APPLICATION NO.	FILING DATE	FIRST NAMED INVENTOR	ATTORNEY DOCKET NO.	CONFIRMATION NO.
10/644,465	08/20/2003	Henry Marshall Israel	2550-001	5945

Office Action Summary

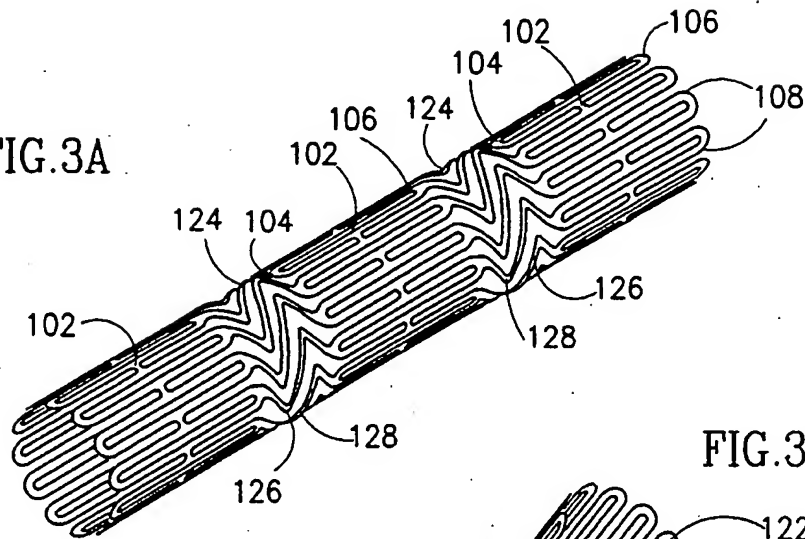
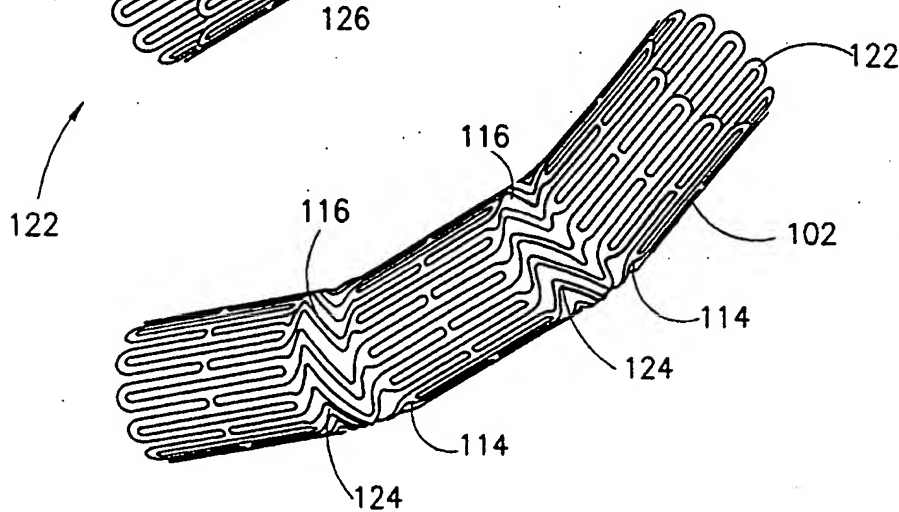
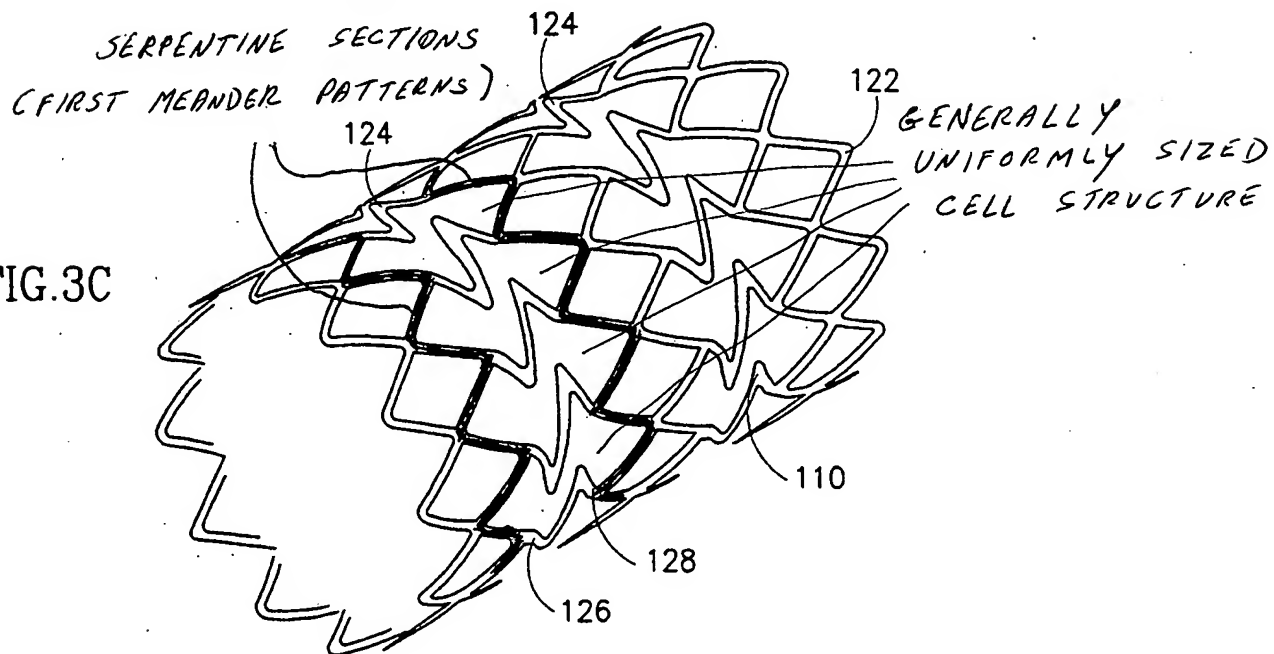
Claims 42, 44-49, 51, 57-60, 63-69 and 72 are rejected under 35 U.S.C. 102(e) as anticipated by or, in the alternative, under 35 U.S.C. 103(a) as obvious over Pinchasik et al. (5,449,373). As to claim 42, Pinchasik et al., in figures 3A-3C, disclose a plurality of continuous serpentine sections (as shown in the attached appendix A), a plurality of flexible connectors 124 forming a generally uniformly sized cell structure (as shown in appendix A), each of the connectors being

elongatable in a bend of a lumen to maintain a generally uniformly sized cell structure in the bend after expansion (the above identified cells will inherently still be generally uniformly sized in the bend since any difference between the cell sizes will be relatively small, particularly in a small bend. Alternatively, it would have been obvious that the cells will still be generally uniformly sized in the bend when the bend is small since any effect the bend would have on the cell size would be small due to the smallness of the bend. As to claim 46, the top end of the Pinchasik et al. connectors are open, closed, open and closed along the longitudinal axis of the stent from the left to the right as seen in figures 3A-3C. As to claim 57, Pinchasik et al., in figures 3A-3C, disclose first meander patterns and second meander patterns as shown in the attached appendixes A and B.
